To: T10 Technical Committee
From: Rob Elliott, HP (elliott@hp.com)
Date: 5 May 2007
Subject: 06-373r2 SAS-2 Zone manager password

Revision 2 (5 May 2007) Incorporated comments from April 2007 SAS protocol WG. Changed title from "key" to "password" as keys are being added in the cryptographically correct way into SPC-4.

Figure 53 — Physical presence detection extending a ZPSDS example [no change]

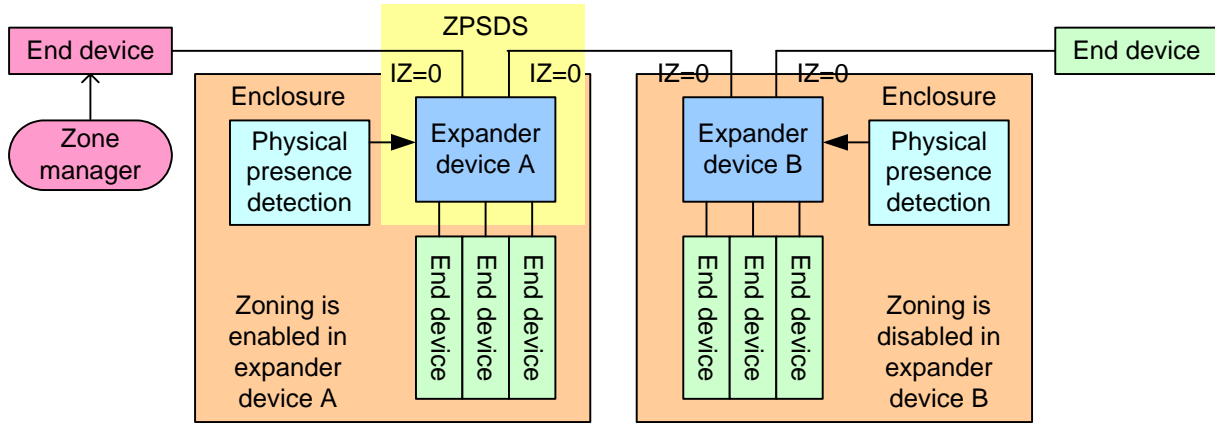
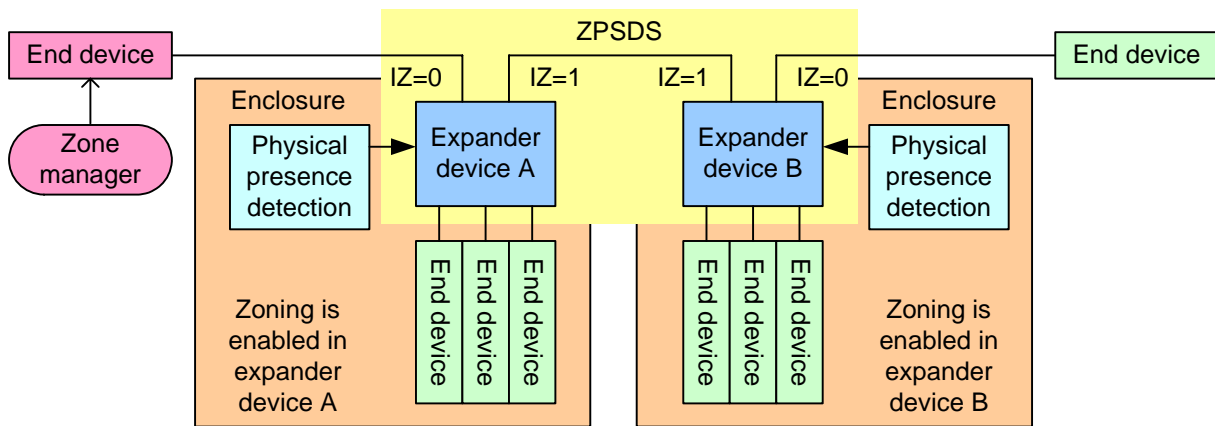
SMP initiator port has access to zone group 2. However, it is not able to enable or configure zoning in expander device B unless physical presence is asserted [or it presents the current zone manager password](#).

Figure 54 — Physical presence detection overtaking a ZPSDS example [no change]

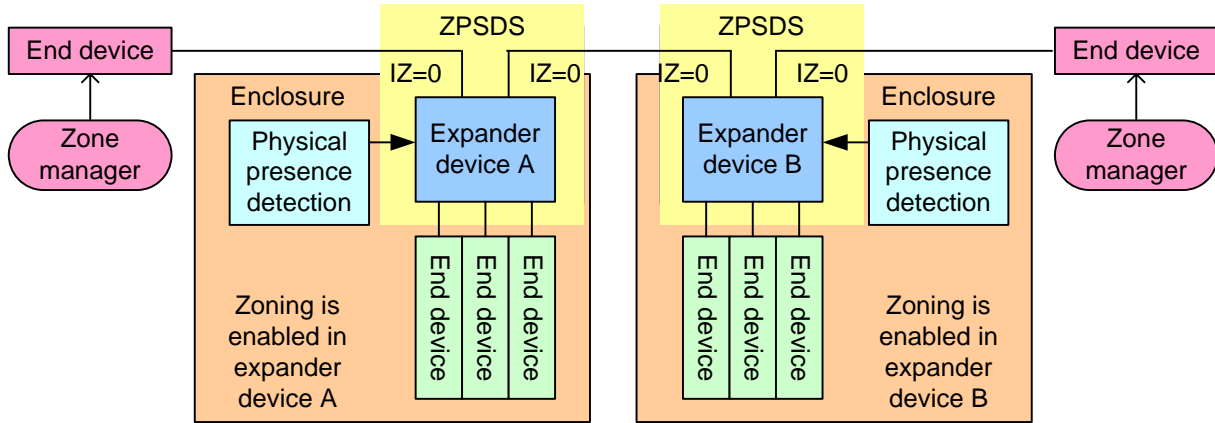
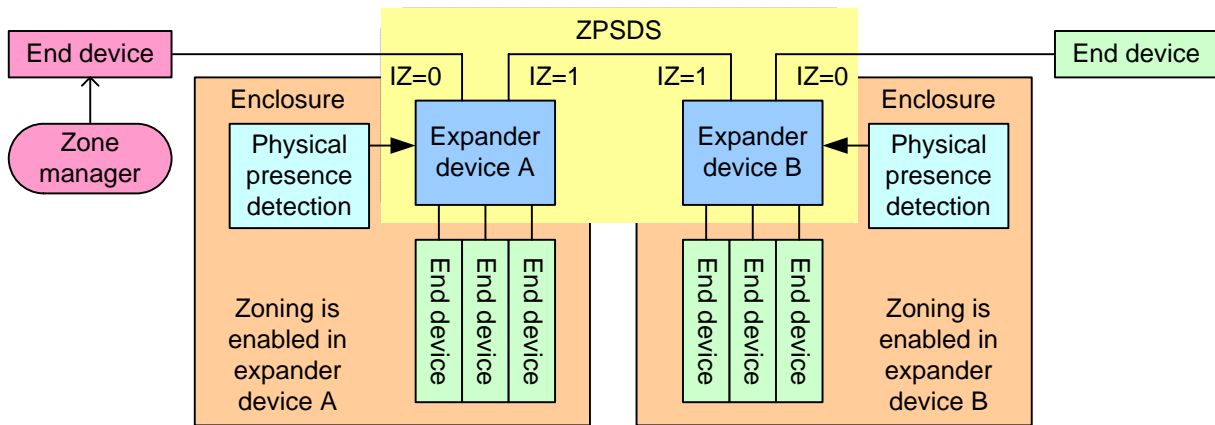
configure zoning in expander device B unless physical presence is asserted [or it presents the current zone manager password](#).
